September 19, 2019

RE: Docket Number EERE–2016–BT–TP–0012: Request for Information for Test Procedure for Dishwashers

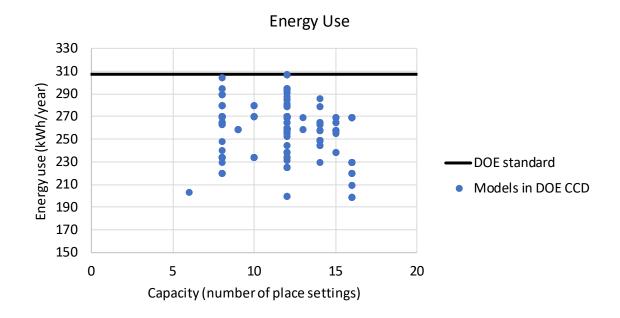
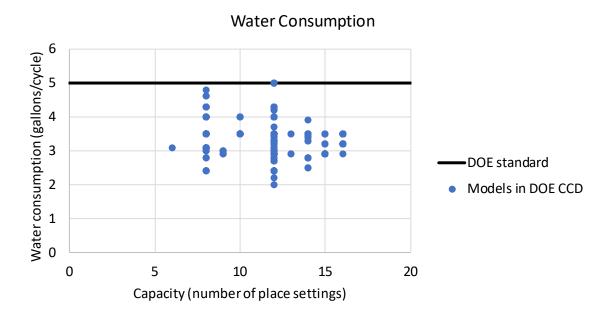
It does not appear that data on current dishwasher models support an approach of establishing energy and water use metrics on a per-place setting basis. The RFI requests comment on a potential approach of establishing energy and water use metrics on a per-place setting basis. DOE notes that China had commented in response to the December 2014 NOPR suggesting a less stringent standard for larger capacity dishwashers. We would not object to an approach of establishing energy and water use metrics on a per-place setting basis provided there was a sound technical reason to do so. However, data on current dishwasher models do not appear to support the need for such an approach. As shown in the graphs below, based on the energy and water use ratings of current dishwasher models certified to DOE, there does not appear to be a relationship between dishwasher capacity (number of place settings) and energy or water use. Furthermore, the dishwasher models with the lowest rated energy consumption (199 kWh/year) have the highest capacity of models certified to DOE (16 place settings), and there are dishwashers across the range of capacities that consume significantly less energy and water than what the standards allow.
